Manorwood Homes

Lince Lane,
Kirtlington

Project Reference: 2207-015/TN/01A

Technical Note

Figure 1 **Figure 7.1 from Manual for Streets**

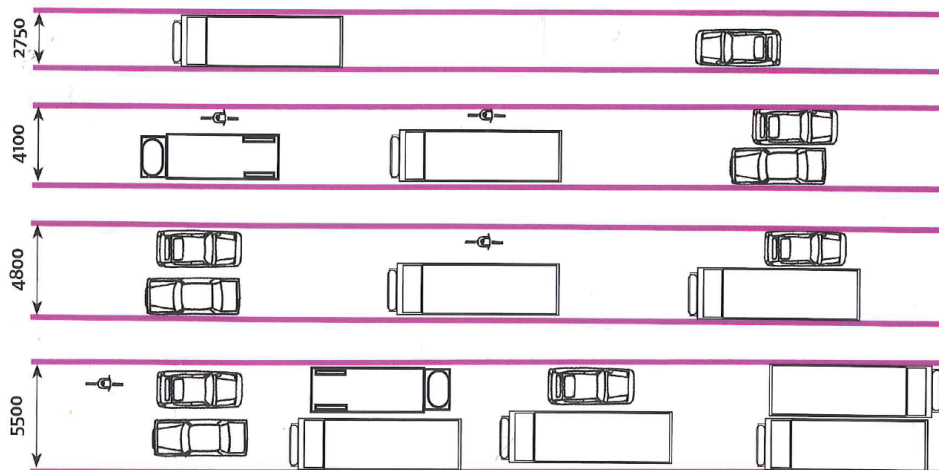
“Given the positioning of the access to this site, it is not going to be possible for refuse vehicles to stop on the A4095. Therefore a swept path analysis for a 11.6m refuse vehicle should be carried out, to prove that it can manoeuvre around the site safely. The vehicle must not overhang any of the footways and should also be tracked passing a parked car.”

- 2.29 With regards to a refuse vehicle passing a parked vehicle, there are two visitor bays provided which should remove the need for vehicles to park on the carriageway. Notwithstanding this, the carriageway has a width of 4.8m which is suitable for a HGV and car to pass, as set out in Figure 7.1 of Manual for Streets, which is reproduced below for ease of reference. Therefore, there is no need for swept paths to show a refuse vehicle passing a parked car.

TITLE: Proposed Site Access Visibility Splays

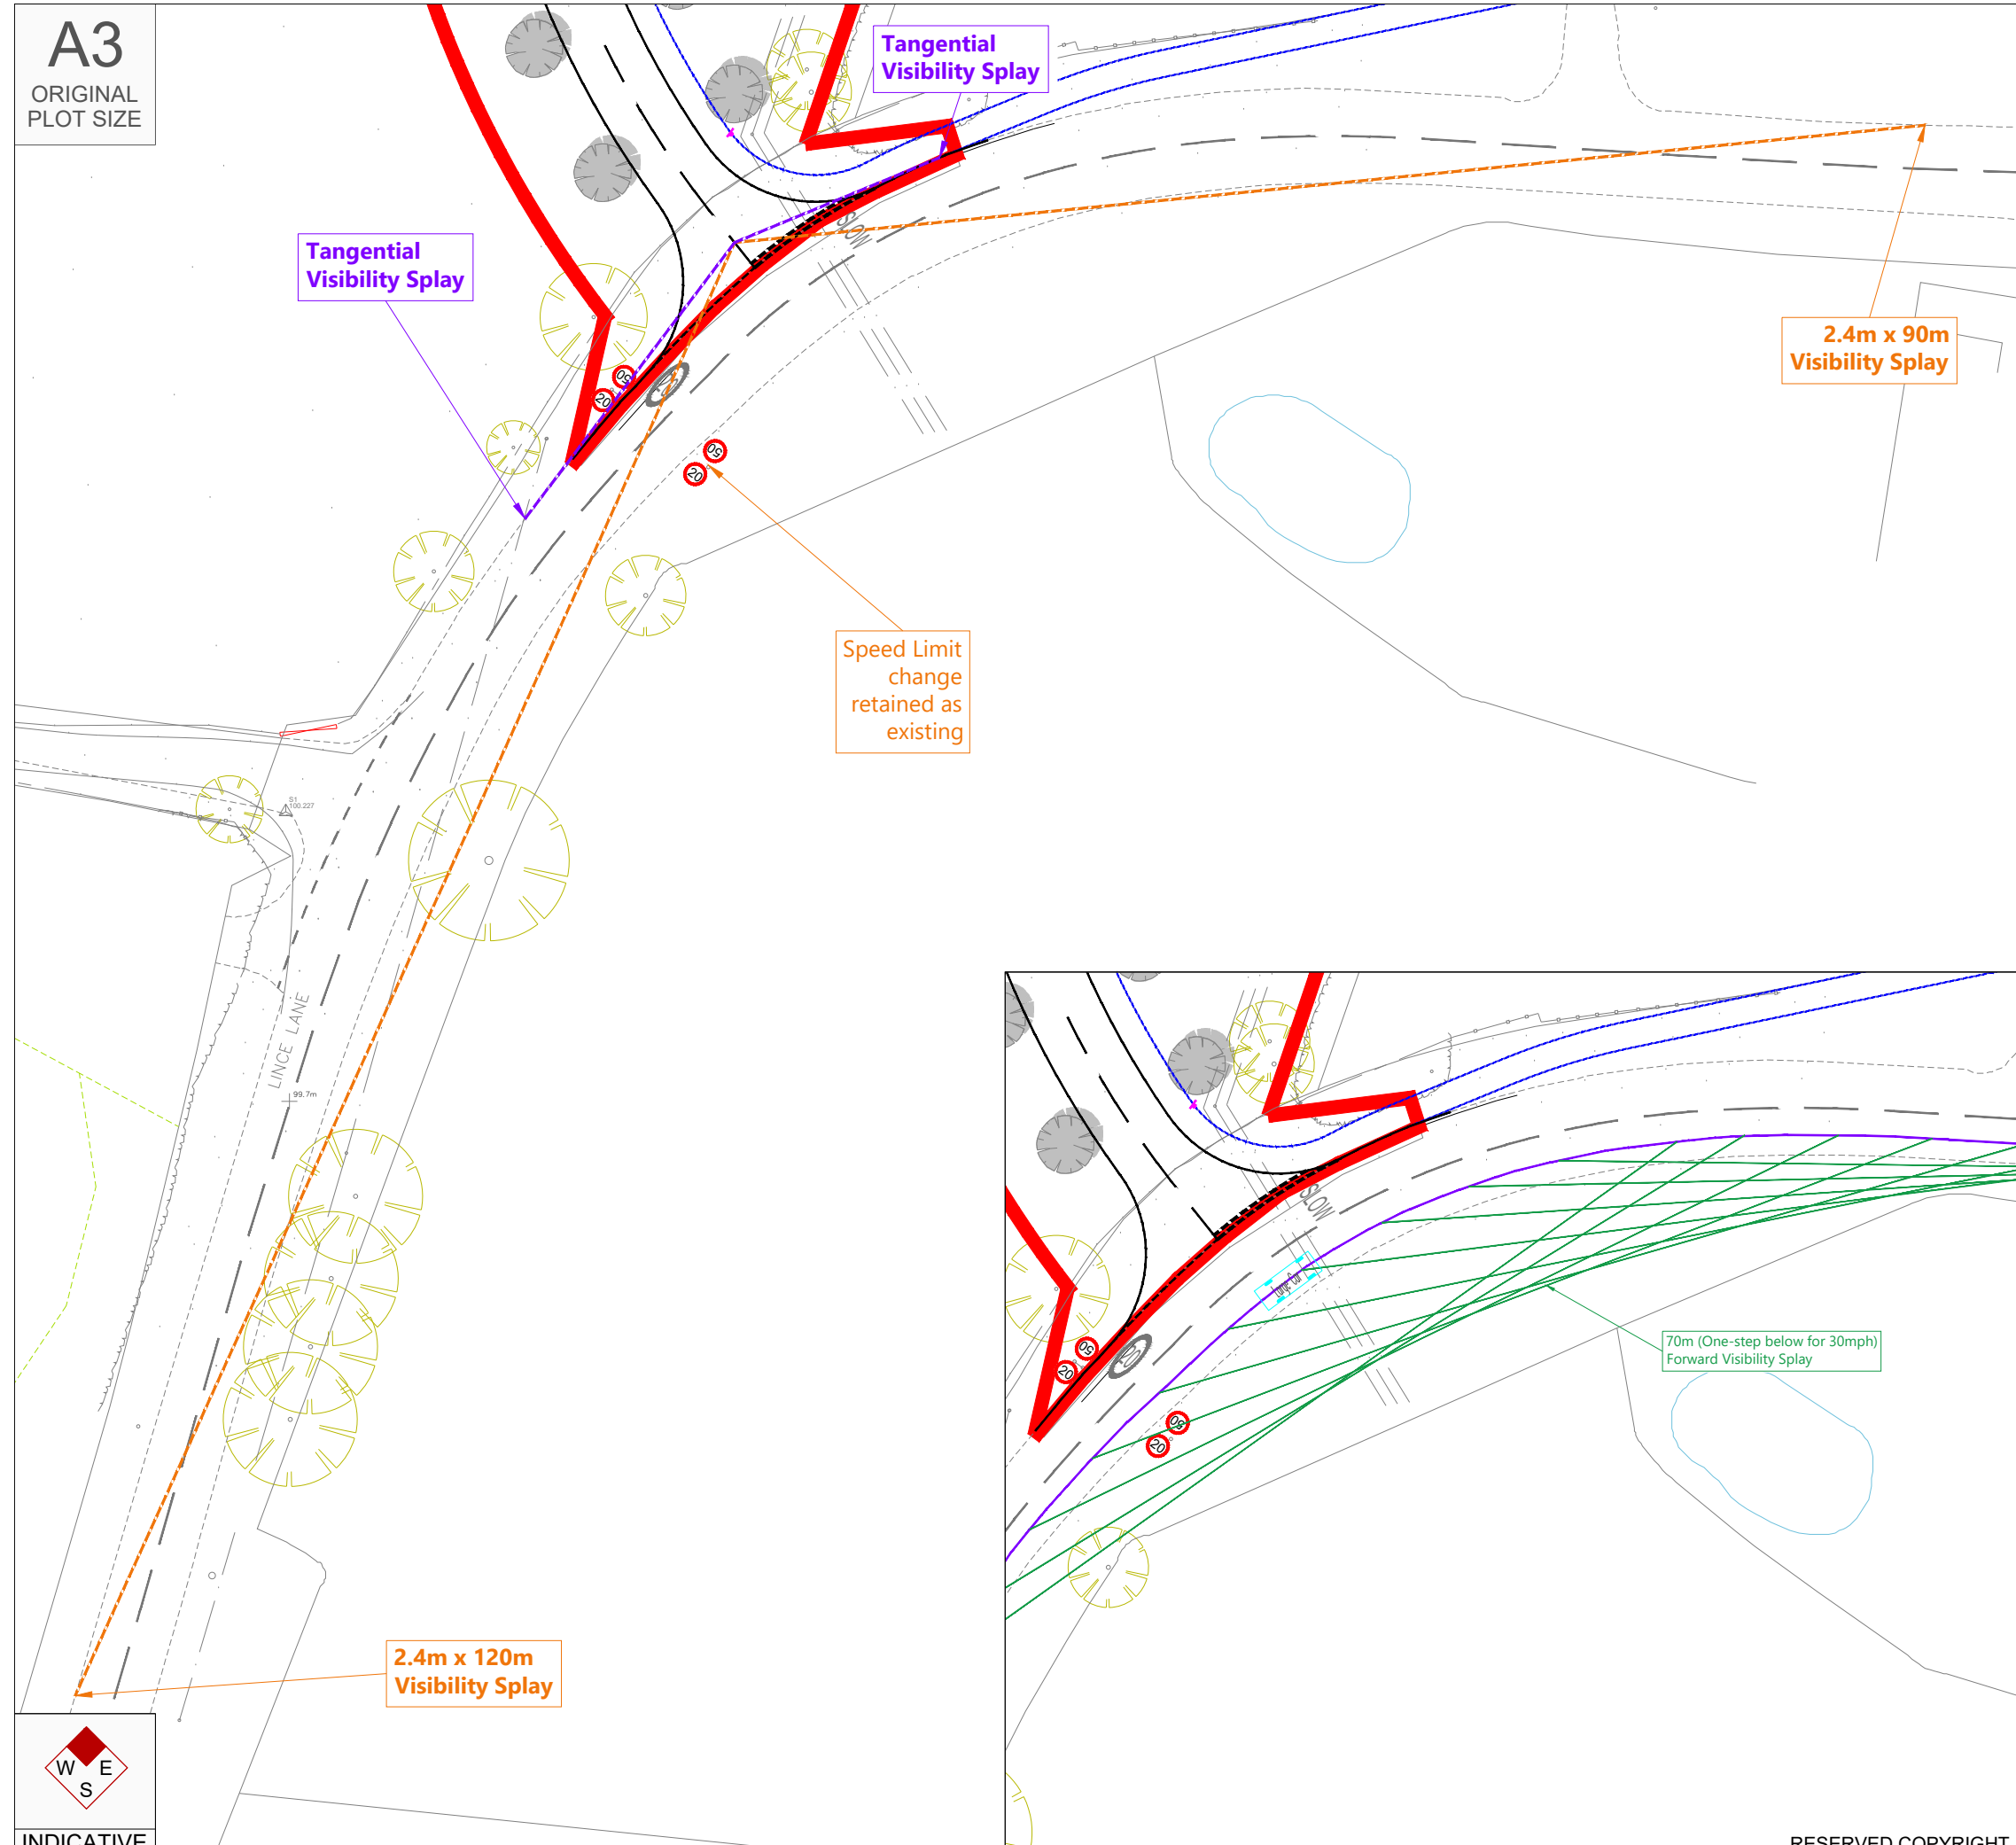
"The proposed access is positioned on a corner that features a prominent crest, limiting visibility. The village has recently changed to a 20mph limit meaning that in normal circumstances, it would only require a 2.4m x 22m visibility splay. However, the access is in close proximity to a speed limit change (50 to 20), meaning that it is likely that speeds could be higher than 20mph as vehicles do not slowdown in time. I would therefore recommend that the applicant is to submit a speed survey, in order to work out the 85th percentile of speed, using this to determine what the required splay should be, this should be conducted over a minimum of 1 week. The splays are then to be submitted to the Local Planning Authority for approval."

2.2 TPA drawing 2207-015 VS01A was submitted as part of the supporting Transport Statement, although for ease of reference a copy of VS01A is attached to this Technical Note. The drawing shows that visibility splays of 2.4m x 120m to the south and 2.4m x 90m to the east can be provided.

2.3 As OCC confirmed, the site access is located within a 20mph zone, with a speed change from 20mph to 50mph just south of the site access. As such the 90m visibility to the east exceeds the require splays for a 20mph road. The 120m splay to the south is in accordance with requirements set out in the Design Manual for Roads and Bridges, which requires a minimum of 120m for a 50mph road.

TITLE: Proposed Site Access

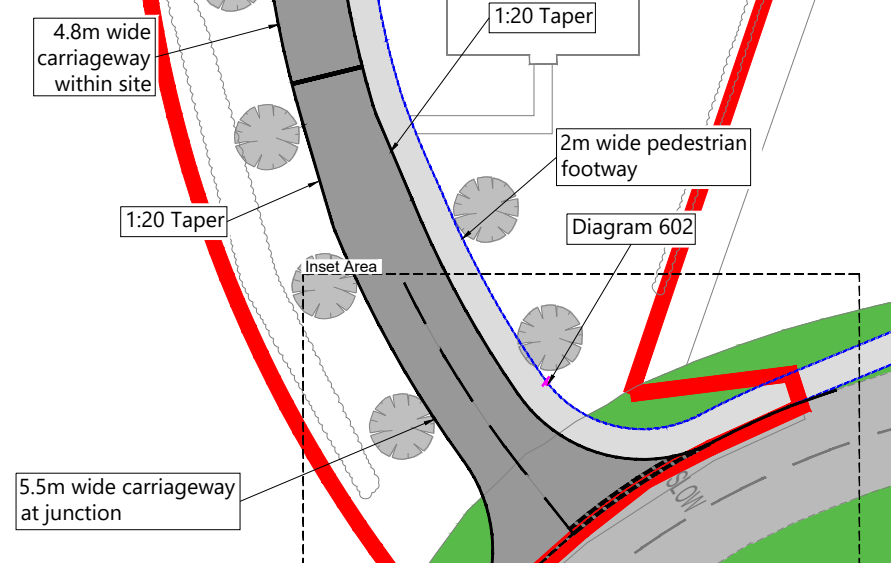
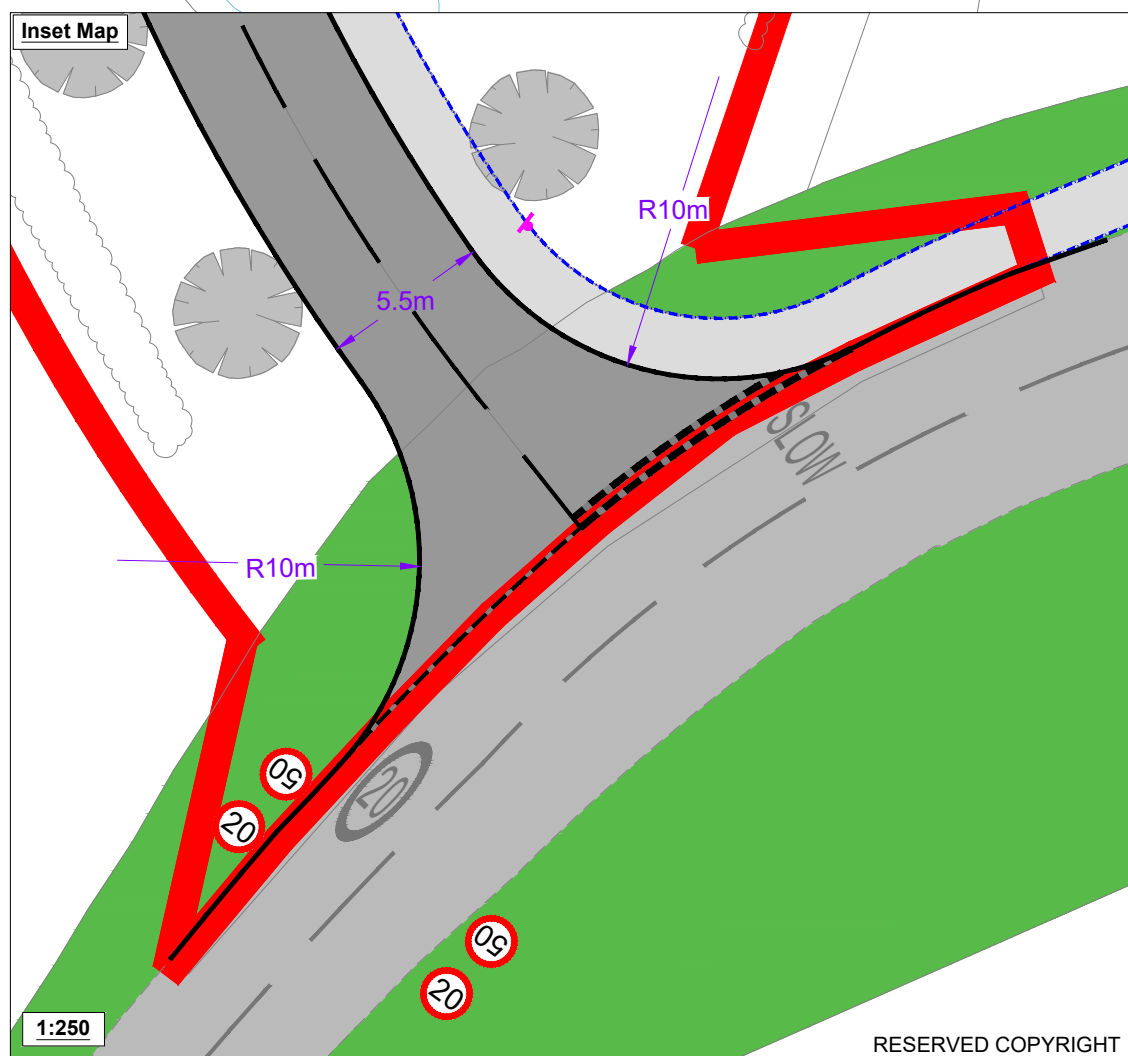
"The current proposals for the site, do not show a pedestrian link from the site to the existing footway network within Kirtlington Village. This means that there is no safe walking route for pedestrians looking to access the village amenities. This presents the obvious safety issue, but also inadequate sustainable travel facilities have the potential to create a car dependent development as per LTN 1/20, something OCC are strongly opposed to.

We will ensure that all new developments have safe and attractive walking and cycling connections to the site, include a connected attractive network for when people are walking and cycling within the development and that the internal routes connect easily and conveniently to community facilities and the local cycle and walking network. It should be noted that currently the design does not conform to the above points."

- 2.8 TPA drawing 2207-015 PL01A was submitted as part of the supporting Transport Statement, although for ease of reference a copy of PL01A is attached to this Technical Note. The drawing shows a 2m wide footway being provided along the eastern side of the proposed site access, with the footway extending east and as annotated on the drawing 'New 2m wide footway to tie into existing footway along Oxford Road'.
- 2.9 To avoid any further confusion, the drawing has been amended to clearly show the new footway joining with the existing footway. The new drawing, 2207-015 PL01C is attached.
- 2.10 As such, there will be no safety issues and residents of the proposed development will be able to walk along a suitable footway to link into the existing pedestrian infrastructure within Kirtlington providing access to local community facilities.

- 2.11 The proposed development provides a 2m footway which would link the site to the existing footway on Oxford Road.

TITLE:
**Proposed Site Access Road
Traffic Calming**

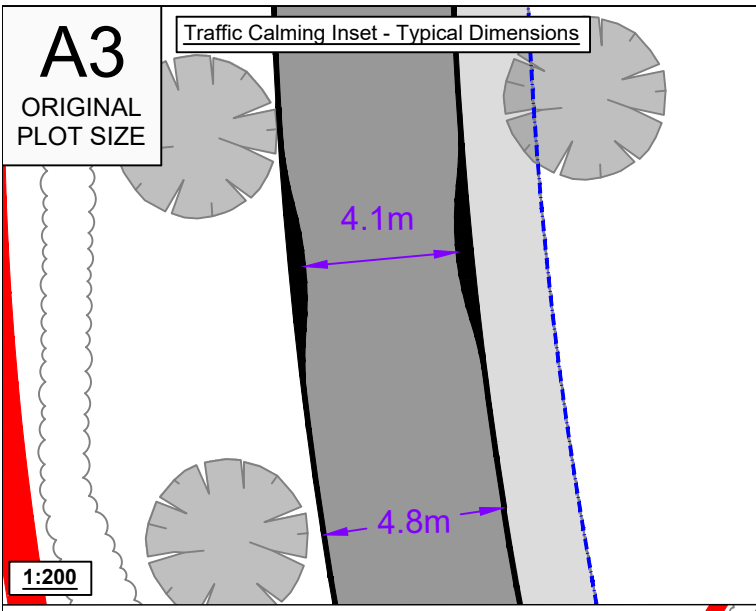
“All sections of road that measure over 70m in length must have traffic calming measures in place to ensure that vehicles speeds remain under 20mph.”

2.22 Following the above comment, the access road layout has been amended to incorporate traffic calming measures, in the form of two narrowing’s. At the two locations the carriageway width will be reduced from 4.8m, through the use of buildouts, to 4.1m, which is the minimum width required to allow two cars to pass. The proposed layout is shown in the attached TPA drawing 2207-015 PL03A.

2.23 The buildouts will be over runnable to enable larger vehicles to pass, but the visual effect of the narrowing’s and the general nature of the road will keep vehicle speeds low.
